Revision of Figure 33-14 v102

Lennart Yseboodt, Matthias Wendt

Philips Research

September 10, 2015

Figure 33-14—POWER_ON state, per pairset operating current templates

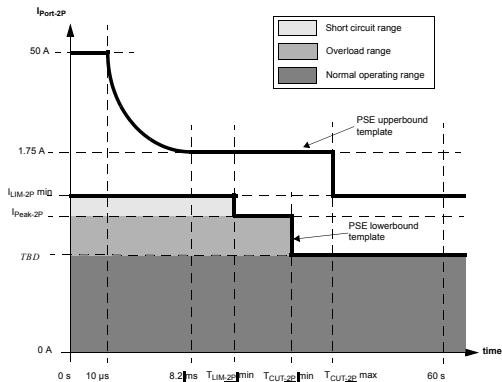
Figure 33-14 together with Equations 33-6 and 33-7 tie together many parameters from Table 33-11. This Figure has been mostly untouched, except for the '-2p' addition. Some issues need to be addressed.

1. There is a TBD in the lowerbound template. We need a way to express unbalance effects in a clear way.
2. $T_{LIM-2Pmin}$ has a value of less than 8.2ms for Type 4
3. Type 4 is limited to sourcing no more than 99.9W, this cannot be expressed by constant current
4. Single and Dual Signature PDs will have a different lowerbound template
5. $I_{LIM-2P(min)}$ is used twice in the Figure, for both the lower and upper template. By making $I_{LIM-2P(min)}$ class-based, the optional I_{CUT-2P} limit is no longer optional.

- ▶ Three new Figures presented to replace Figure 33-14
- ▶ Covers all cases (4 Types, 2 Signatures, 2/4 pair mode)
- ▶ Unbalance is shown in a simple intuitive way
- ▶ All issues on slide 3 are addressed

Figure 33-14a (2 pair & dual-signature)

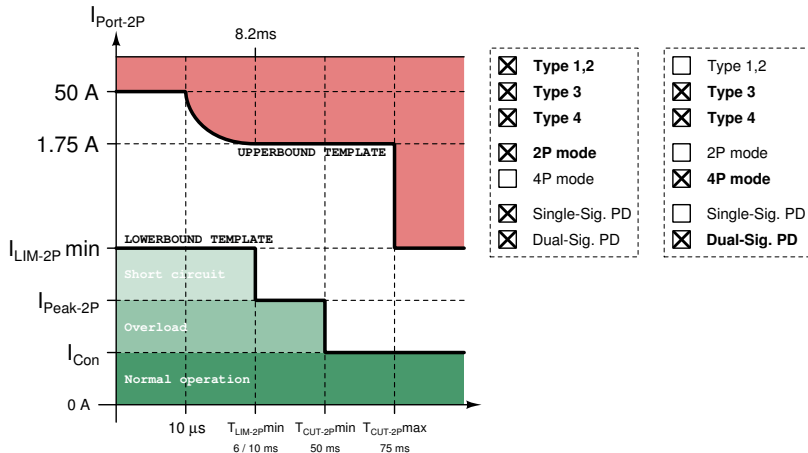
Applies to all PSEs in 2-pair mode, as well as PSEs connected to dual-signature PDs.

PSEs connected to a single-signature PD shall meet I_{Con} and $I_{\text{Con-2P_unb}}$ as specified in Table 33-11. PSEs connected to a dual-signature PD shall meet I_{Con} on each pairset as specified in Table 33-11.

P_{Class} applies to the full power at the PI, but is treated on a per pairset basis for dual signature PDs. The same method is appropriate for I_{Con} , it applies to each pairset independently when connected to a dual signature PD.

Figure 33-14b (Type 3, 4-pair, single-signature)

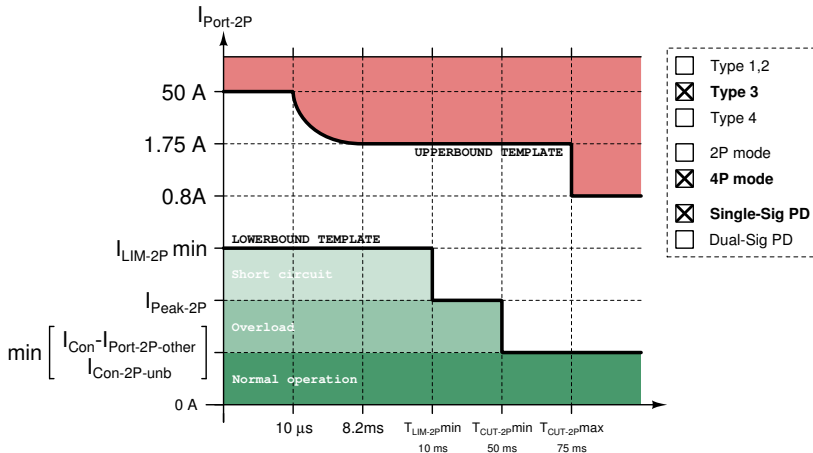
Applies to Type 3 PSEs, operating 4-pair mode, connected to single-signature PDs.

Figure 33-14c (Type 4, 4-pair, single-signature)

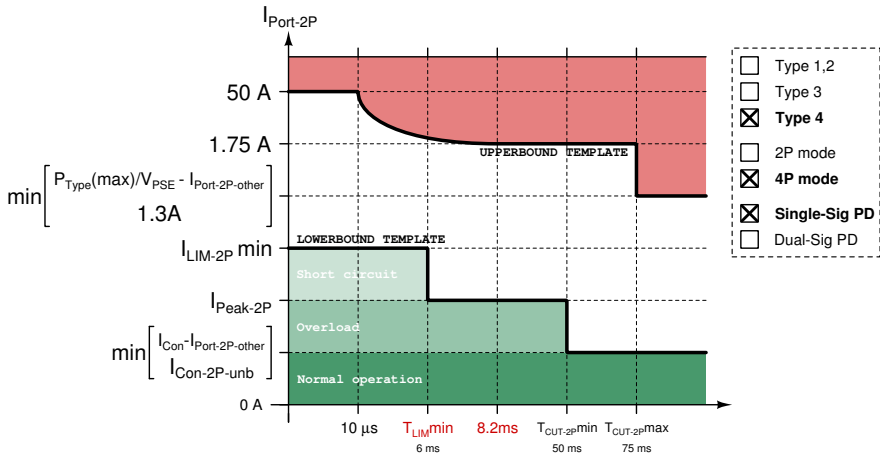
Applies to Type 4 PSEs, operating 4-pair mode, connected to single-signature PDs.
